Approval Sheet

PART NO.: SA130D-24U (replace 69-797-37)

DESIGN NO.: A130D15401-2

CHANGE NOTICE

59-00114-4

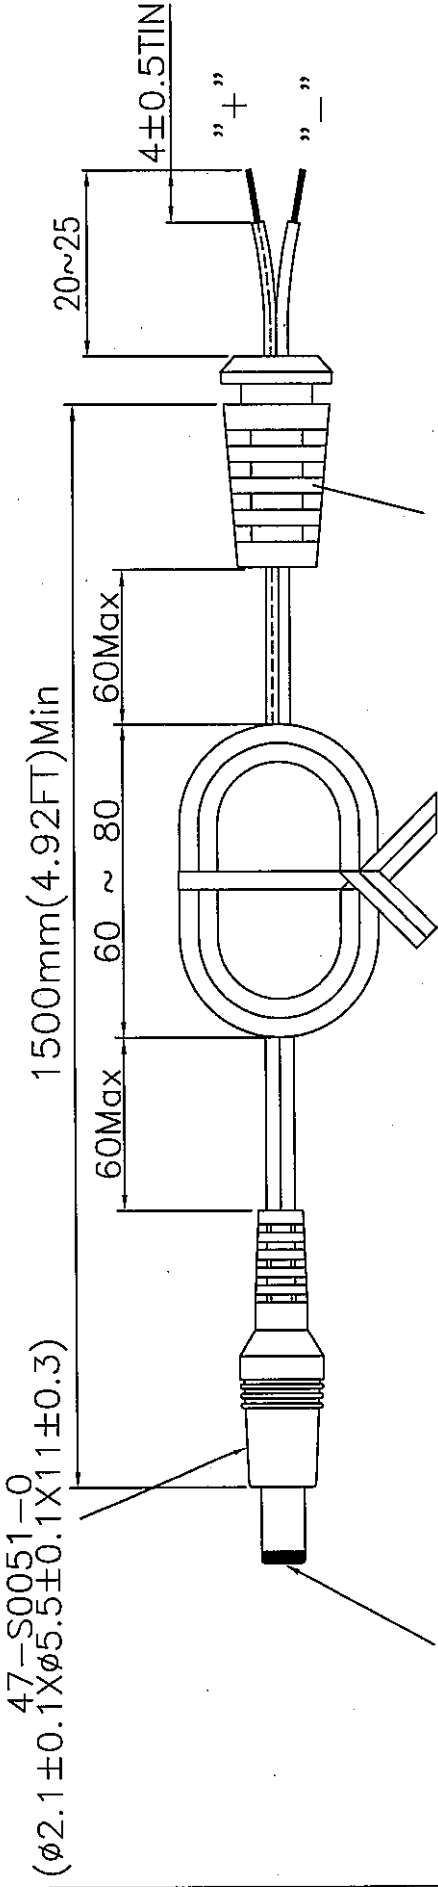
REMARK: change to UL2468 wire

ORIGINAL DESIGN NO. : A130D15401-1	REVISED DESIGN No. : A130D15401-2
<p>DC CORD : 4.92 Ft UL 1185 18*2C</p>  <p>UL 1185 AMG18 80°C</p>	<p>DC CORD : 4.92Ft UL 2468 22*2C</p>  <p>UL 2468 AMG22*2C</p>
Customer Approved by :

REV.	DATE	BY:	DESCRIPTION OF CHANGE
-2	27-Oct-15		Change the DC CORD.

8-3 Output Cable : 1500mm UL 2468 AWG22*2C , with Plug : 2.1*5.5*11 S
Polarity : Center "+"

UL 2468 AWG22*2C
